Architectural Review Board

Staff Report (ID # 11076)

Report Type:	Action Items	Meeting Date: 3/5/2020
Summary Title:	1700 & 1730 Embarcadero Road: Mercedes and Audi Dealerships (2nd Formal)	
Title:	PUBLIC HEARING / QUASI-JUDICIAL. 1700 & 1730 Embarcadero Road [19PLN-00291]: Recommendation on Applicant's Request for Approval of a Major Architectural Review to Address the Following Outstanding Issues for a Previously Approved Auto Dealership Project: Color, Landscaping, Parapets, Lighting, Transportation Demand Management Plan, County Airport Land Use Commission Review; and Floor Area Ratio. Environmental Assessment: Addendum to an Initial Study/Mitigated Negative Declaration that was Adopted for the Project on June 24, 2019. Zoning District: CS(D)(AD). For More Information Contact the Project Planner Sheldon Ah Sing at sahsing@m-group.us.	
From:	Jonathan Lait

Figure 1: Shade Tree Conflict

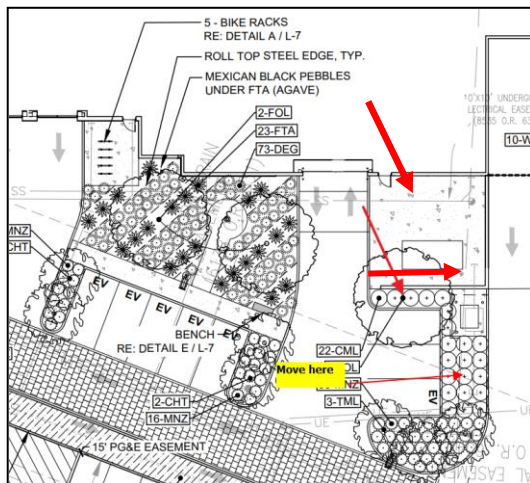
The City's Urban Forester concurs with the proposed plant palette and locations with the exception of one of the fruitless olive trees. The fruitless olive tree proposed adjacent to an equipment enclosure along the Bayshore Road elevation (See Figure 1) would not be likely to survive. The wall is a part of an enclosure screening a back-up power generator for the facility. The alternative location includes an underground electrical line. Staff recommends that the underground electrical utility be routed in such a way to avoid conflicts with the relocated tree.

6. RELOCATION OF TREE: The owner or designee shall demonstrate the relocation of the fruitless olive tree in front of the generator enclosure of the Mercedes Benz building to the adjacent landscape finger area between the enclosure wall where the California Mountain Liliac plants are located and the Chaste Trees on plans prior to the issuance of building permits.

Figure 2: Comparison of Bayshore Road Elevation

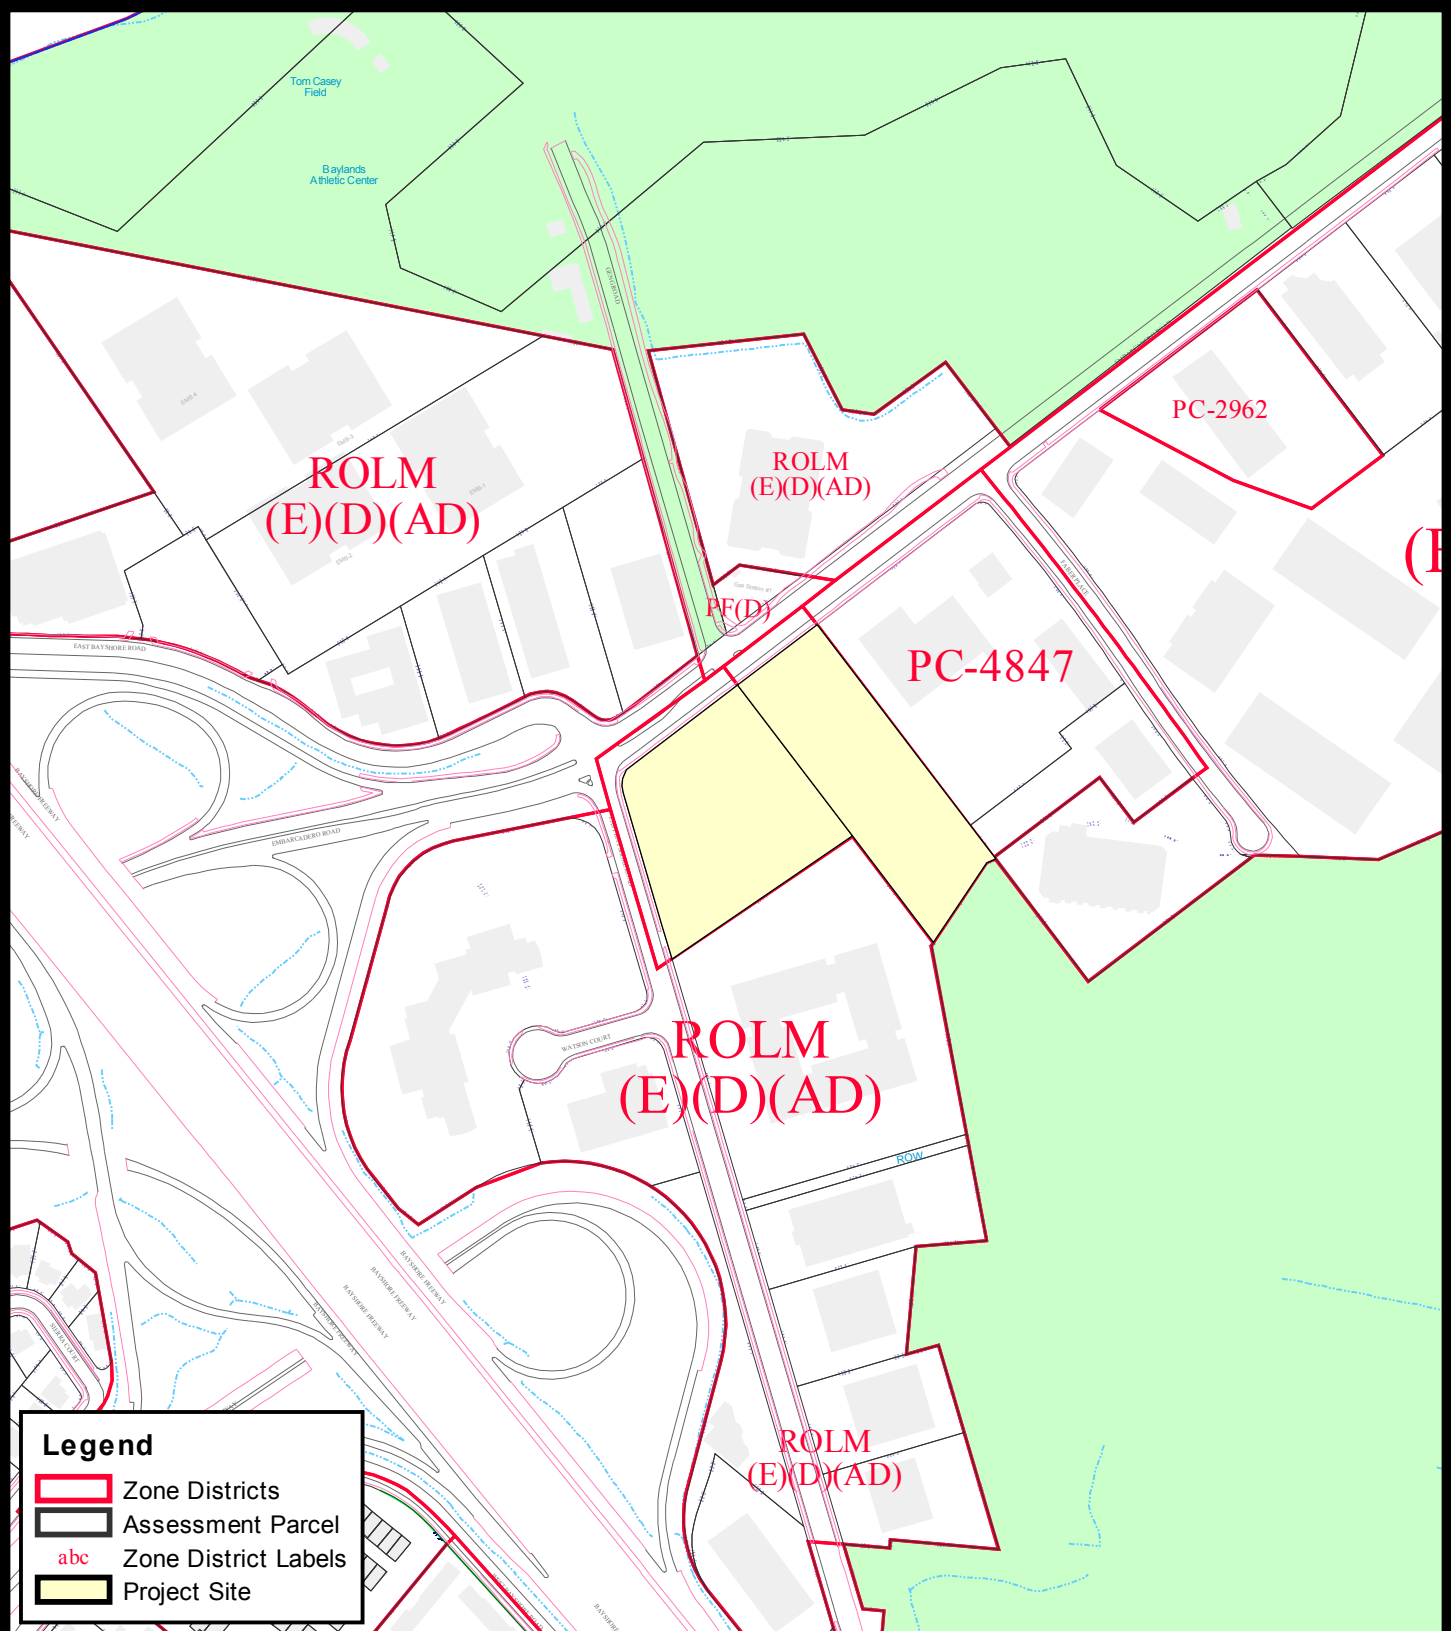
• <u>Bayshore Road Elevation:</u> With the proposed change to the elevation, reducing the floor area, the Bayshore Road Elevation needs more continuity. The right side of the stairwell tower reads like the back of the building.	The elevation on the right side of the stairwell tower now continues a similar design theme as on the other side of the tower. This design wraps around the rear of the building slightly. <i>Appears to resolve issue. See Sheet ZA203 & ZA202. See Analysis section for further discussion.</i>

At the prior ARB meeting, board members noted that the Embarcadero Road elevation had a lot of variety in massing and materials used. In contrast, the uncertainty of the design of the Bayshore Road elevation with the recessed first floor resulted in mixed ARB comments on the elevation. The portion of the elevation on the left side of the stairwell tower showed a stronger relationship to Embarcadero Road. The right side of the stairwell tower was designed with more relationship to the rear of the building. Given the visibility of the elevation, and coupled with the proposed change to the elevation, the ARB encouraged greater consideration for continuity of the Bayshore Road elevation. The ARB wanted that elevation to be like the left side, where those materials would wrap around the corner to the rear of the building.

The updated elevation repeats the louvers and ribbed metal paneling to the right of the stairwell. The ribbed metal paneling wraps around the rear slightly. The opaque glass panels also continue on both sides of the stairwell tower. The revisions make the project more consistent with Architectural Review Finding #2. For instance, the revisions provide a better transition in character from Embarcadero Road to Bayshore Road.
